Moorebank Intermodal Precinct East – Stage 2 Modification 3

Subdivision of two additional lots, changed frequency for compliance reporting, changed signage requirements and administrative updates to conditions.

State Significant Development Modification Assessment
(SSD 7628 MOD 3)

December 2020

Figure 7 | Examples of warehouse identification signage (Source: Applicant's MOD 1 Modification Report)

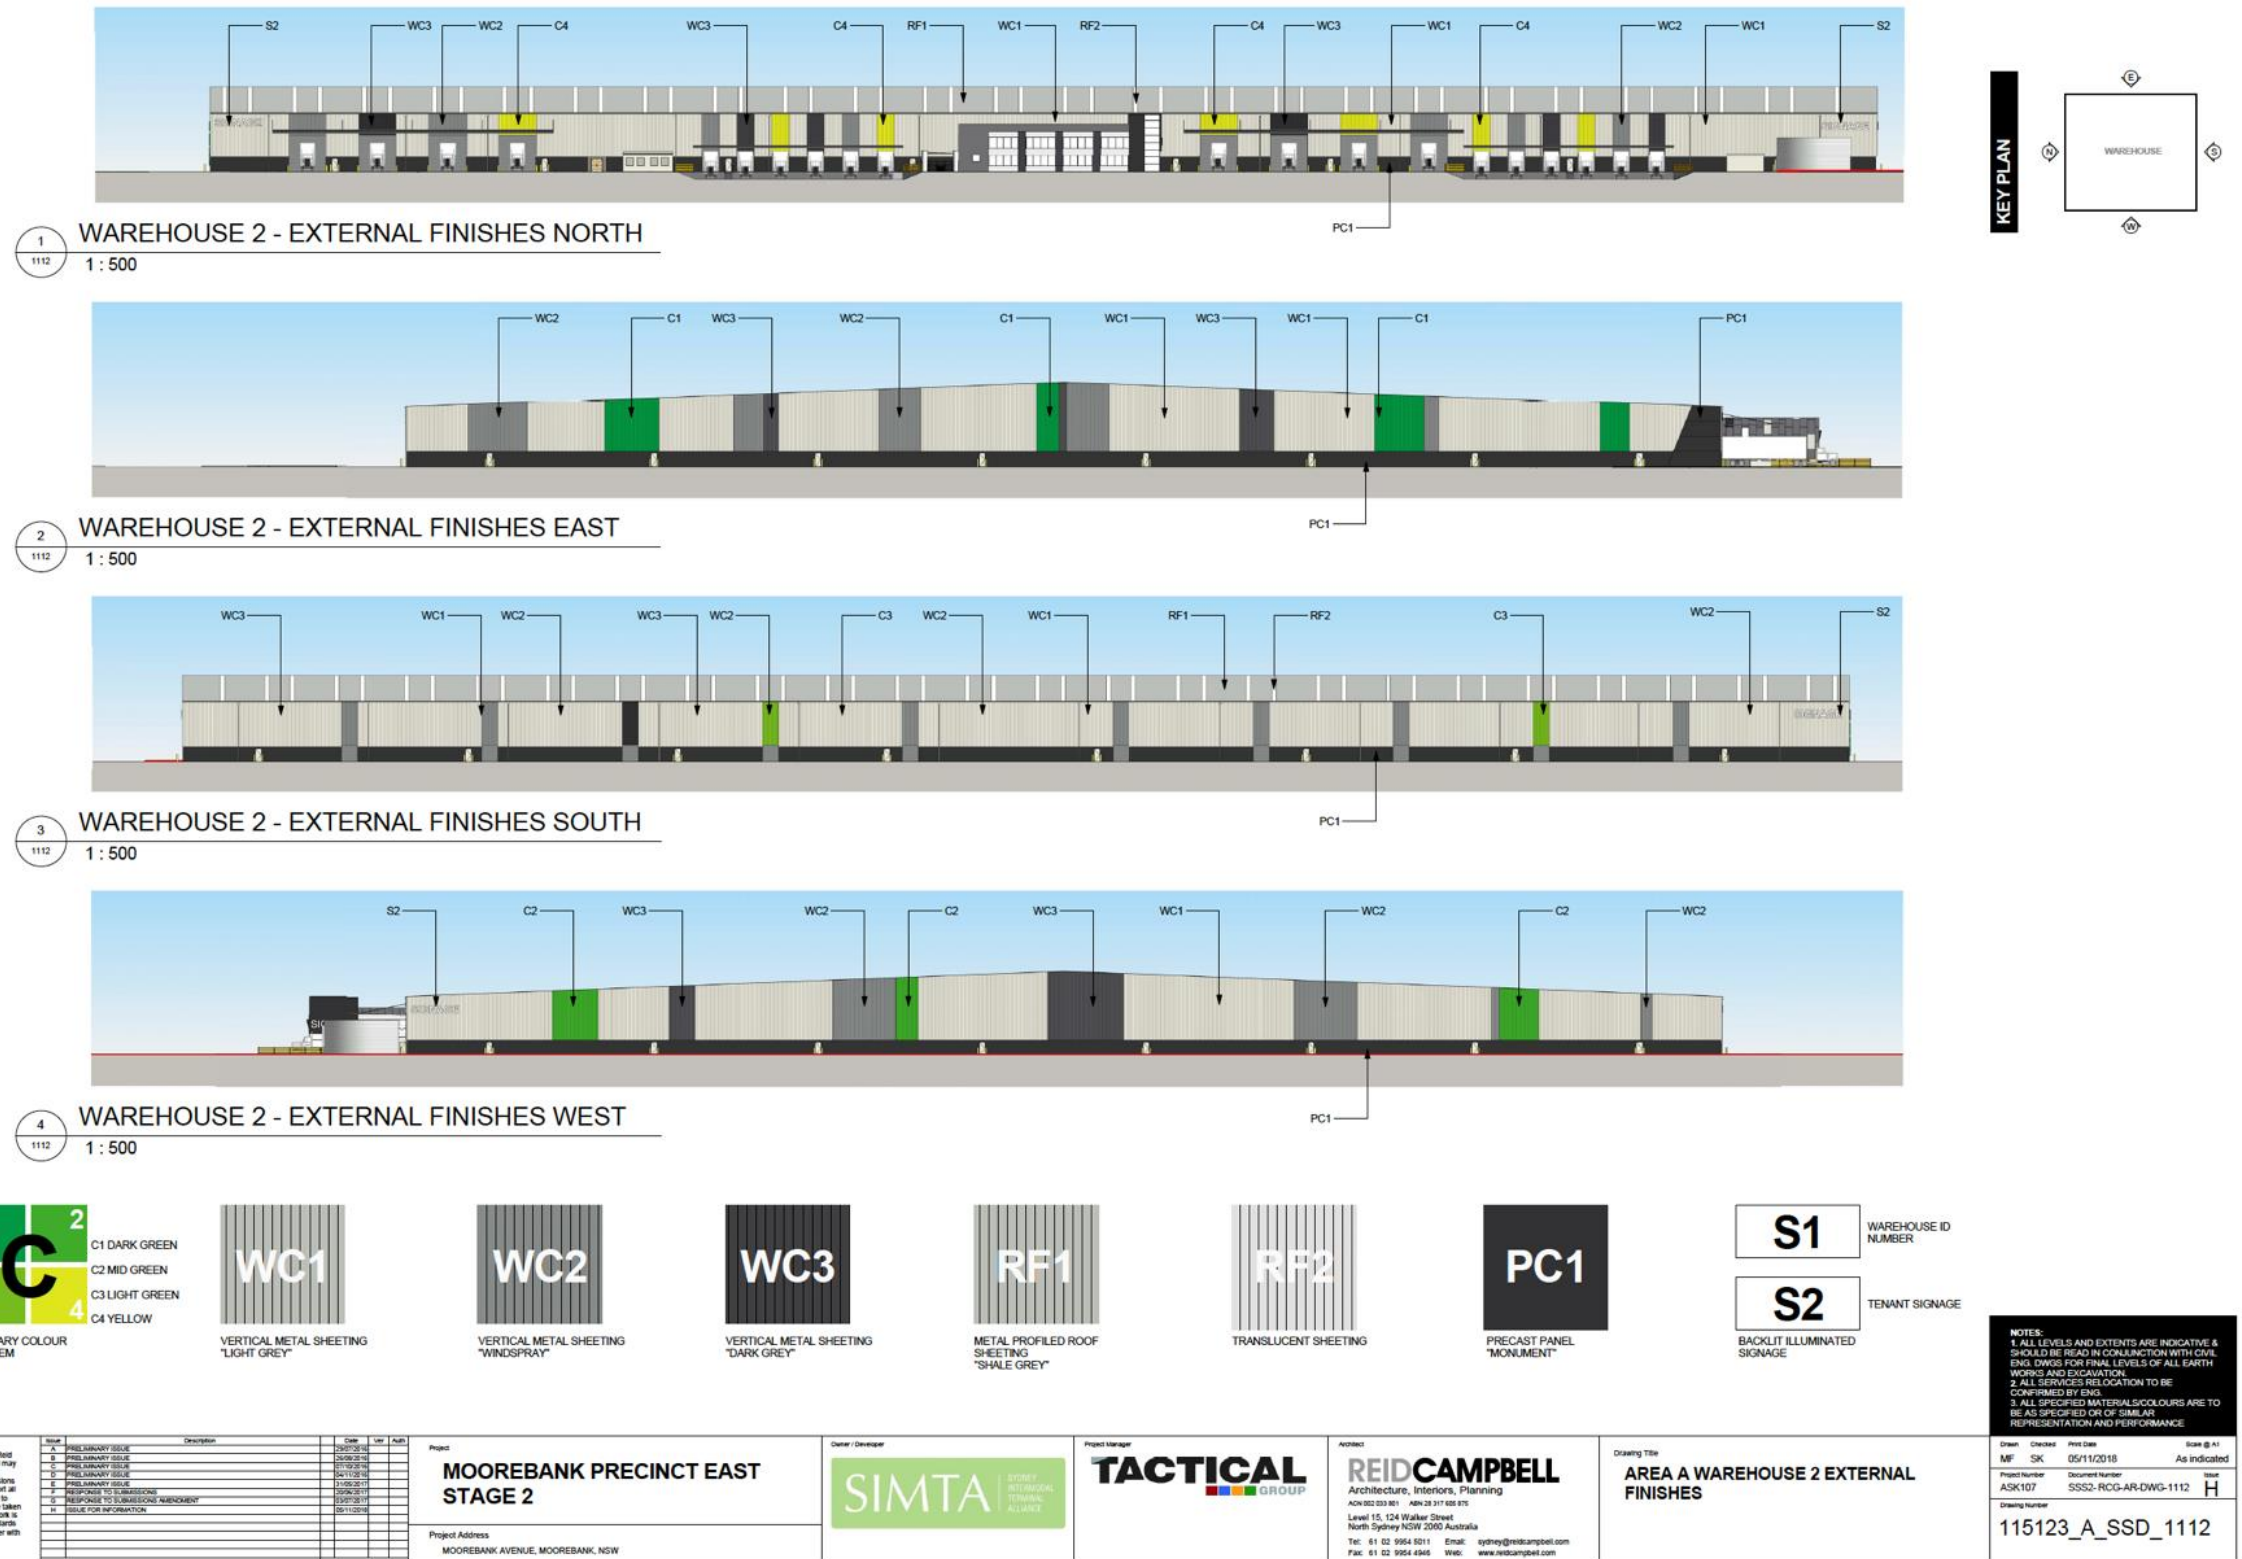
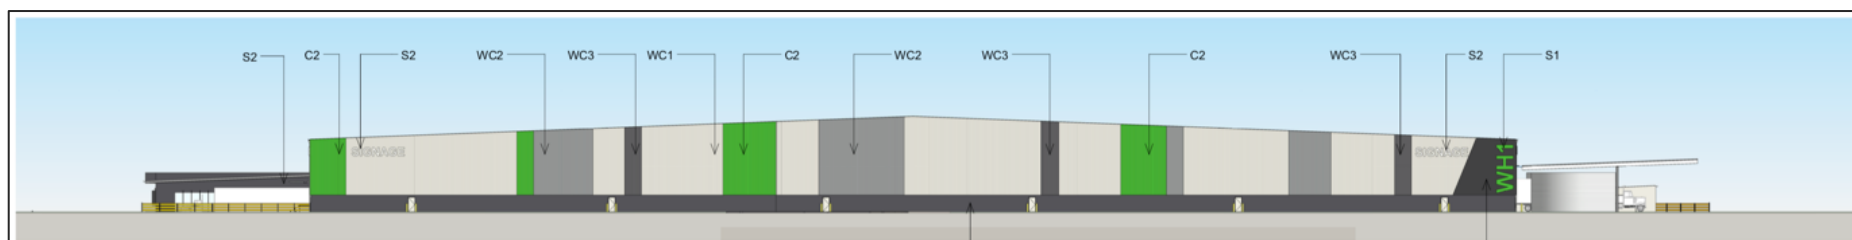
In their submission, Council and public submitters raised concerns about the potential off-site visual impacts of raising the permissible height of integrated building signage. The Applicant notes in the MPE Stage 2 MOD 1 RtS that it is not proposed to install additional signage, or to alter the building forms, and therefore proposes the existing visual impact assessment presented in the EIS for the project remains relevant. The Department accepts this position, as there is no proposed change to the height or frame of buildings.

However, the Department notes that the deletion of B141(f)(ii) is proposed by the Applicant as part of the modification. The Department therefore recommends that only the portion of the condition relating to the 3-metre height restriction be removed and the condition be modified to read:
